**1958 Agreement – Consideration of draft amendments
to existing Regulations submitted by GRE**

Proposal for Supplement 11 to Regulation No. 99 (Gas discharge light sources)

Submitted by the Working Party on Lighting and Light-Signalling*

Insert new sheets D9S/1 to 5, after D8S/5, to read (see following pages; one page per sheet):

Figure 1
Category D9S - Cap PK32d-9

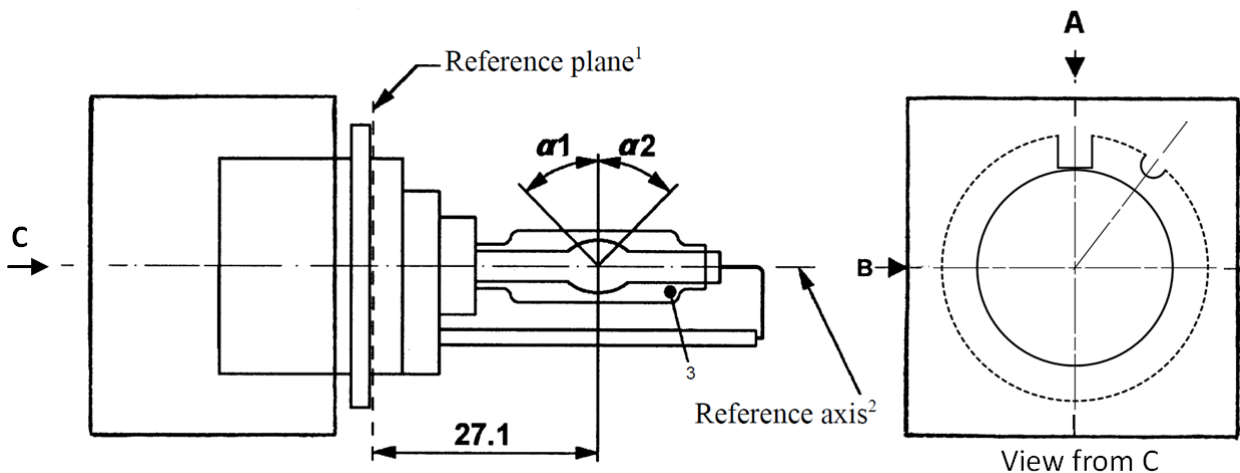
¹ The reference plane is defined by the positions on the surface of the holder on which the three supporting bosses of the cap ring will rest.
² See sheet D9S/2.
³ When measured at a distance of 27.1 mm from the reference plane and with respect to the mid-point of the inner bulb, the outer bulb shall have an eccentricity of 1 mm max.

Figure 2
Definition of reference axis¹

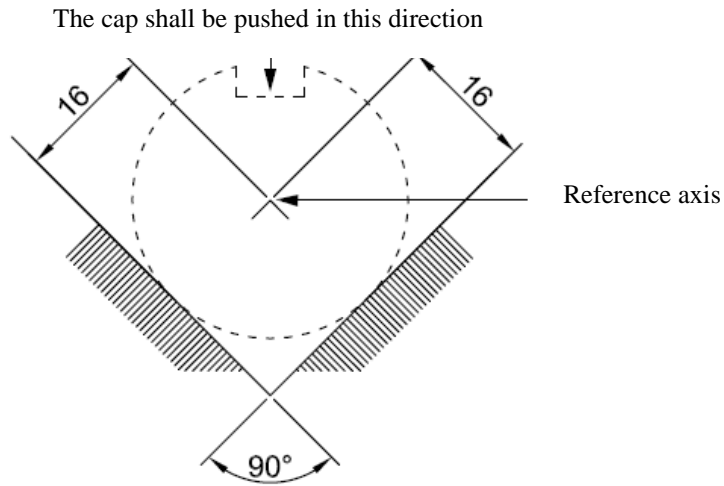
¹ The reference axis is perpendicular to the reference plane and crosses the intersection of the two parallel lines as indicated in figure 2.

Figure 3
Maximum lamp outline²

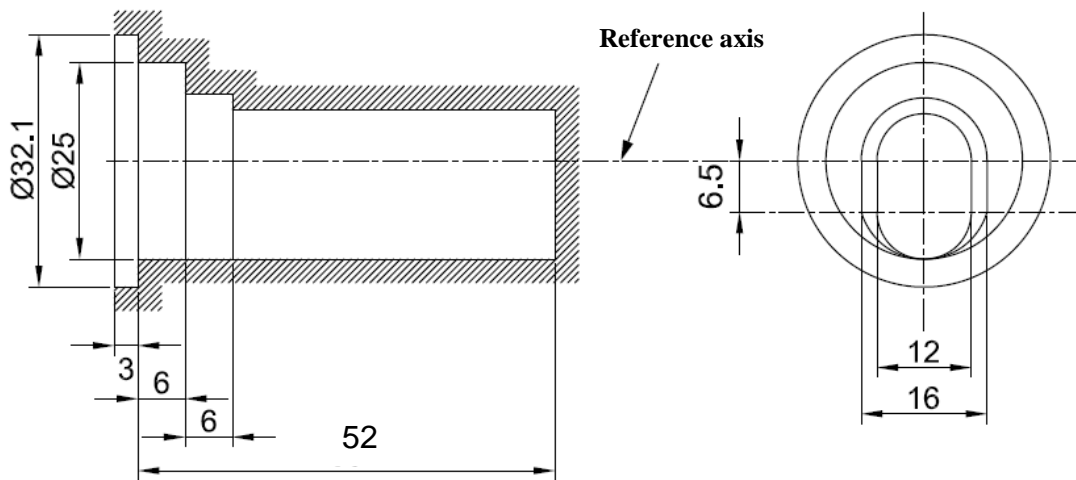
² Glass bulb and supports shall not exceed the envelope, as indicated in figure 3. The envelope is concentric with the reference axis.

Position of the electrodes

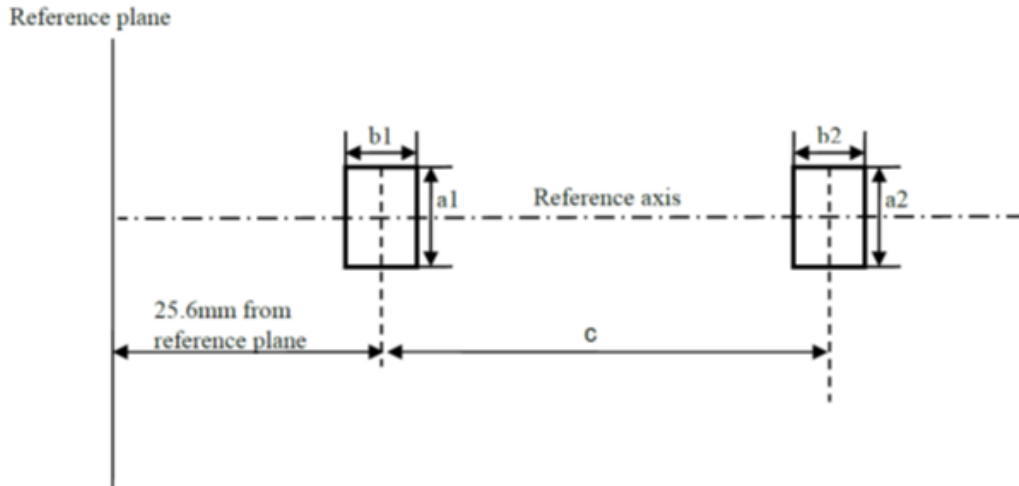
This test is used to determine whether the electrodes are correctly positioned relative to the reference axis and the reference plane.

<i>Dimension in mm</i>	<i>Production light sources</i>	<i>Standard light sources</i>
a1	0.30	0.20
a2	0.50	0.25
b1	0.30	0.15
b2	0.60	0.30
c	3.00	3.00

The arc attachment point to the electrode nearest to the reference plane shall be positioned in the area defined by a1 and b1. The arc attachment point to the electrode furthest from the reference plane shall be positioned in the area defined by a2 and b2. The geometrical data is valid for 27W and 35W operation.

Position and form of the arc

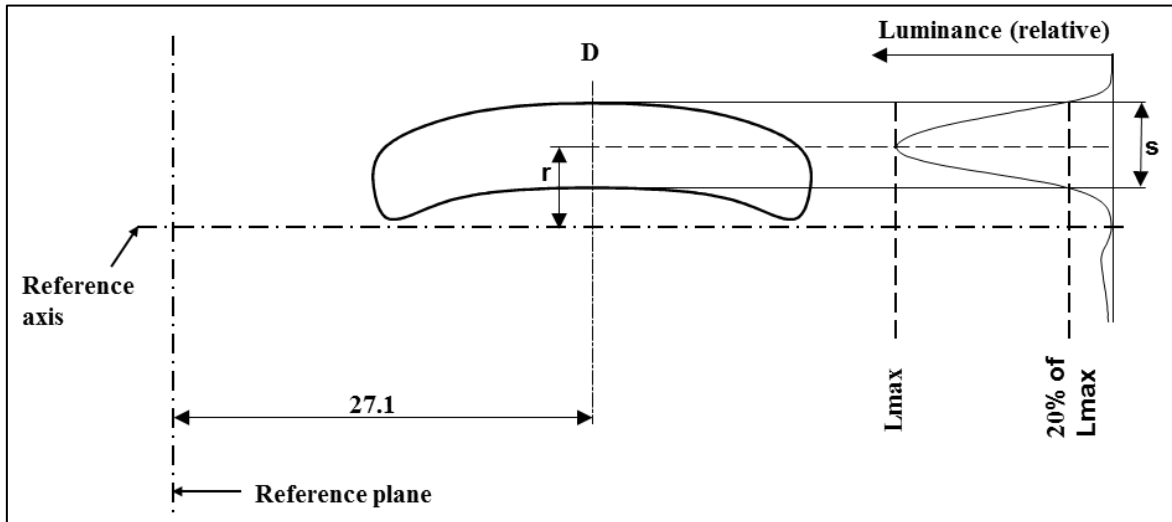
This test is used to determine the form of the arc and its position relative to the reference axis and the reference plane by measuring its bending and diffusion in the cross section at a distance 27.1 mm from the reference plane.

When measuring the relative luminance distribution in the central cross section as indicated in the drawing above, the maximum value shall be located within the distance r from the reference axis. The point of 20 per cent of the maximum value shall be within s . The geometrical data is valid for 27W and 35W operation.

<i>Dimension in mm</i>	<i>Production light sources</i>	<i>Standard light sources</i>
r (arc bending)	0.35 +/- 0.25	0.35 +/- 0.15
s (arc diffusion)	0.80 +/- 0.25	0.80 +/- 0.15
